Enquiries: Andrew Leckie
Project No: 310205844

**RE: Lake Tekapo Ropes Course
Mackenzie District Council RFI- Transport Responses**

Figure 2: 2023 Daily Traffic Volumes on SH8, East of Lake Tekapo (NZTA TMS)

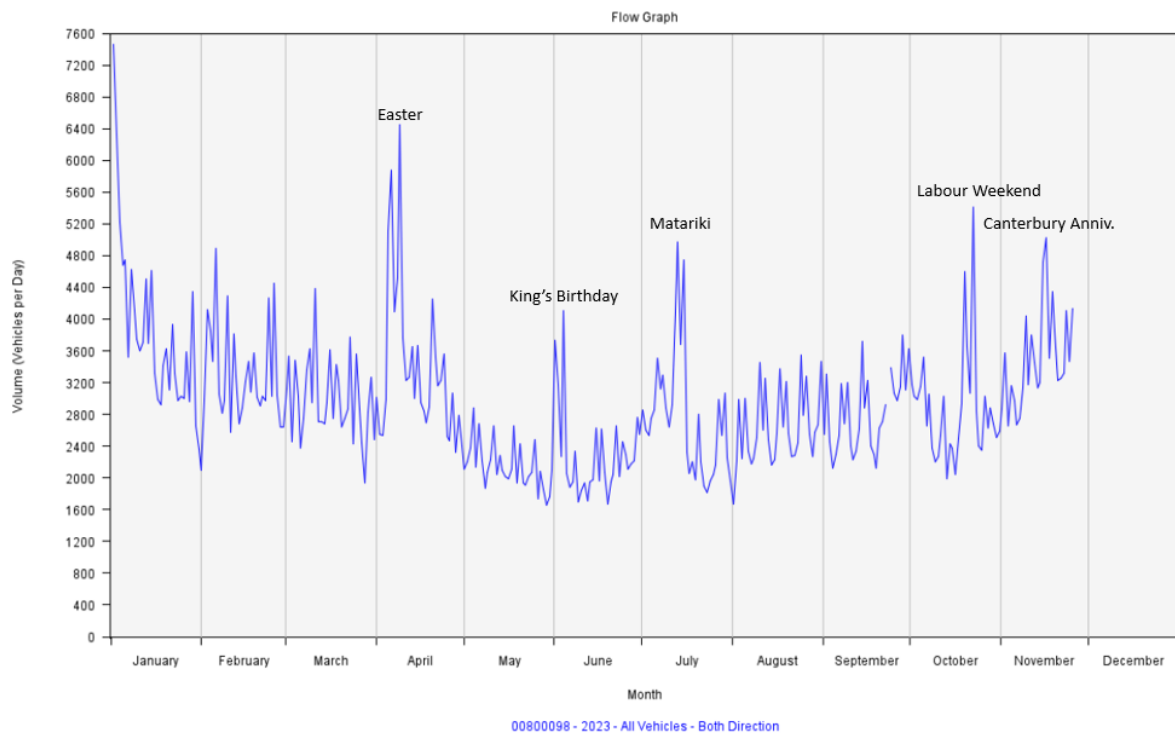
The figure below, taken from the NZTA TMS website, presents daily traffic volumes recorded on SH8 east of Lake Tekapo. It shows that the Matariki long weekend in the middle of July was one of the busiest weekends of the year in

It is acknowledged that during the middle of winter there is very little activity at the lakeside and clearly Sunday 16 July 2023 was not a busy day in the area of the proposed ropes course. However, it is considered that this level of activity would be representative of much of the year in this location.

The RFI presents a photograph taken on a hot Saturday afternoon in January (during school holidays). The above traffic data shows that January is the busiest month of the year in Lake Tekapo, and this day, being a hot Saturday during school holidays, will likely be one of the very busiest days of the year at the lakeside. Car parking demands during the very busiest times of the year are not typically used for assessment purposes, as it is not an efficient use of resources to design to meet all car parking demands.

Figure 5: Diagram Highlighting Parking Area In Front of Base Station

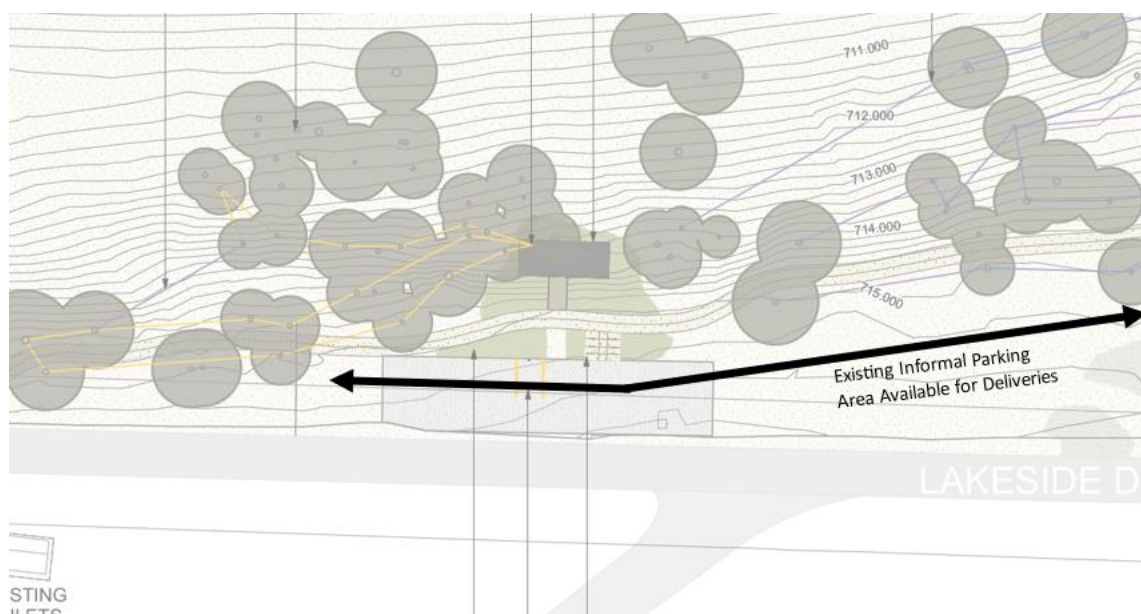
- f) *No loading is proposed. The traffic assessment notes that delivery vehicles are expected to be infrequent and small in size, if required at all. Any small and infrequent delivery will be able to use the informal parking*

area in front of the base station and it is considered that any associated manoeuvring will have a negligible effect on the safe and efficient operation of Lakeside Drive. Please indicate on the site plan where the unloading of delivery vehicles will occur.

The below image includes a black arrow indicating where existing informal car parking will remain with the ropes course operational. Any infrequent, small delivery vehicles, such as those supplying a vending machine within the base station, will be able to make use of the informal parking area, noting that any deliveries would be expected on weekdays outside of peak times.

Figure 6: Cycle Parking Area Annotated

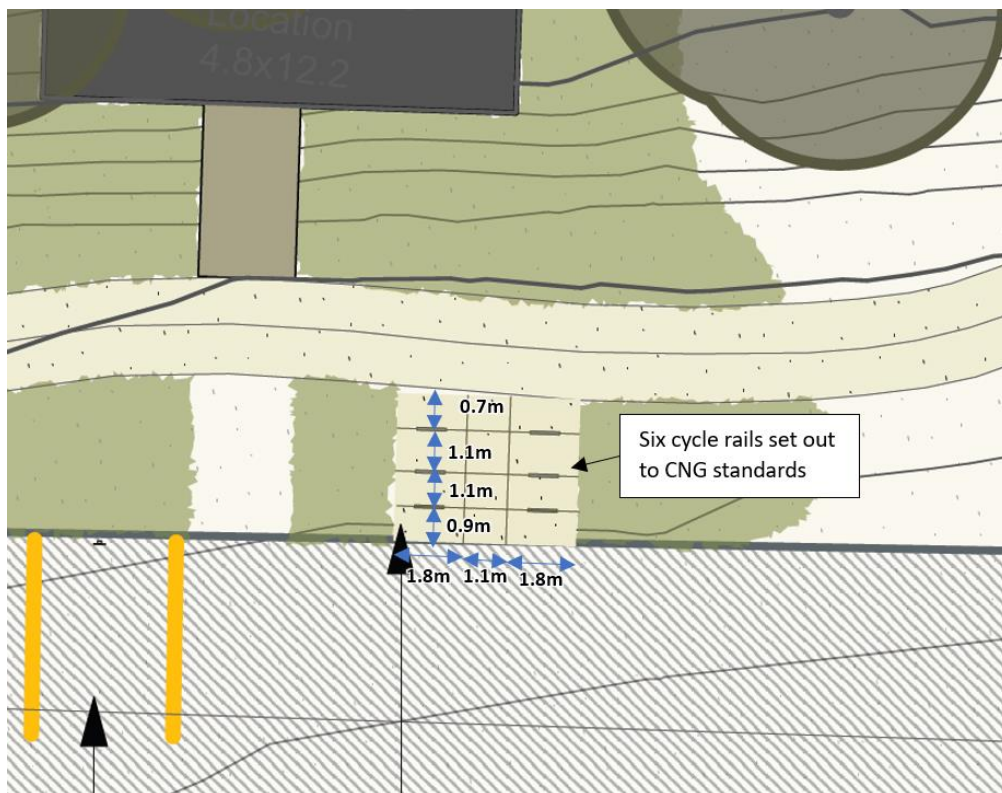
- g) Please show the proposed bike parking on the site plan. Please assess whether the bike parks will reduce / interfere with any existing parking in the area.*

Stantec Response: The landscape plan shows the cycle parking located between the car parking area and the existing lakeside path. It is proposed in an area 4.7m long by approximately 3.8m wide. As shown below, it will be possible to set out six cycle rails to NZTA Cycle Network Guidance (CNG) standards. The set out would include 0.9m separation to the car park, 1.1m between cycle rails and 0.7m separation to the shared pedestrian / cycle path. This will be more than adequate for a bicycle to rest against one of the end rails clear of the path. The cycle parking will not impact the existing car parking or the operation of the path.
